## REMARKS

Docket No. 1522-K-CONT

Enclosure - Replacement drawings sheet (Figs. 17 & 18)

FIG-18

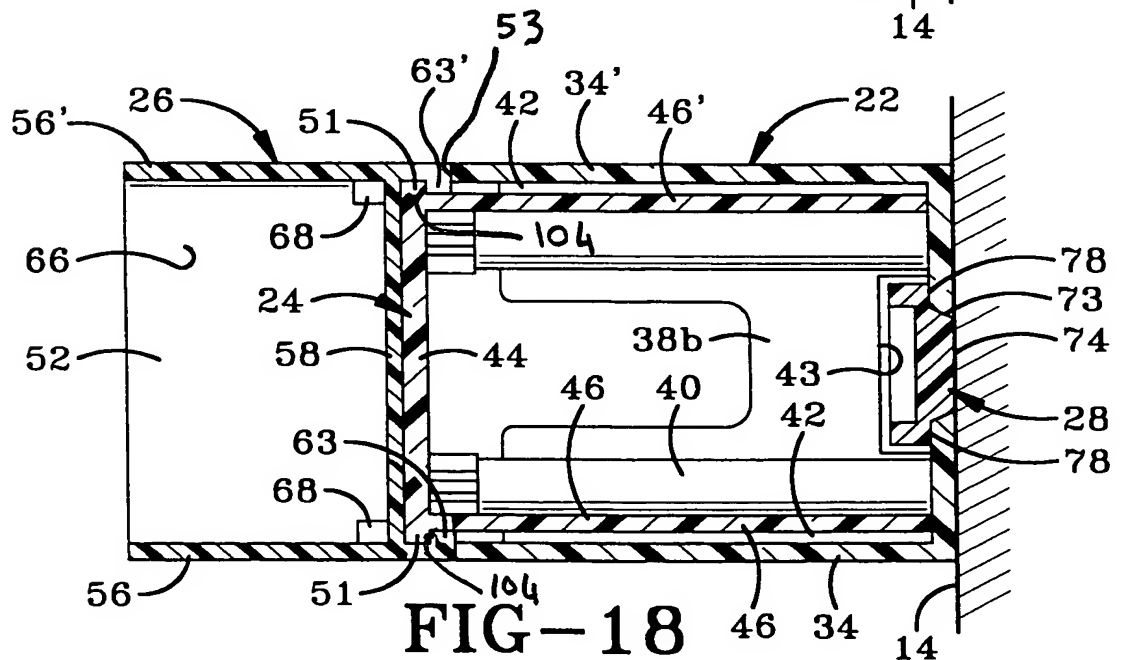
**The Examiner objected to the drawings under 37 C.F.R. 1.83(a) in that the drawings need to show every feature of the invention specified in the claims.**

Specifically, the Examiner requires that the "front wall" (line 3 of claim 1); "first connector mechanism" (line 6 of claim 1) and "second connector mechanism" (line 9 of claim 1) must be shown or the feature(s) canceled from the claims. **In response,** Applicant respectfully submits that these features are already shown in the drawings.

The **"first connector mechanism"** is shown in Fig. 18, the first connector mechanism being an interlocking ridge/boss and a groove. The first connector mechanism thus comprises the rim 51 on the bracket interlockingly received within the second groove formed between the rear wall 58 of the rail connector and the ridge 63 of the rail connector. Alternatively or additionally, the ridge 63 is interlockingly received within a first groove formed between the end of the side wall 34 or 34' and rim 51.

Applicant attaches hereto a replacement drawing sheet including Figs. 17 & 18. In the amended Fig. 18 the second groove has been numbered "104" in conformity with page 8, lines 3-6 of the specification and with Fig. 9 which shows the details of the rail connector prior to attachment to the bracket. Furthermore, the amended Fig. 18 shows the first groove which has now been numbered "53" in accordance with Fig. 3 and page 6, lines 8-12 of the specification. The rim 51 interlocks with the second groove 104, and

the ridge 63 interlocks with the first groove 53 and thereby join the rail connector and bracket together. The first and second grooves 53, 104 have been numbered for ease of use of Fig. 18 when reading the specification. No new matter has been added by way of this amendment.
